October 13, 2023

Regarding: **Block 2002, Lot 26, Borough of Hillsdale**  
**6 Willow Brook Road: Variance Application PZ-04-23**  
**Ms. Selina Ramoutar, Applicant and Owner**

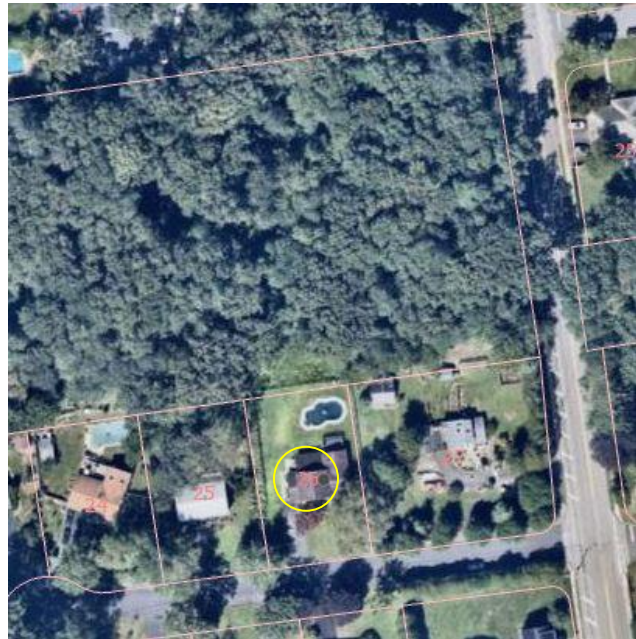
1. The applicant is responsible for providing the required testimony for the need for all variances. The positive and negative criteria must be satisfied.
2. The property directly to the north is owned by The County of Bergen as part of Wood Dale Park (see photo to right).
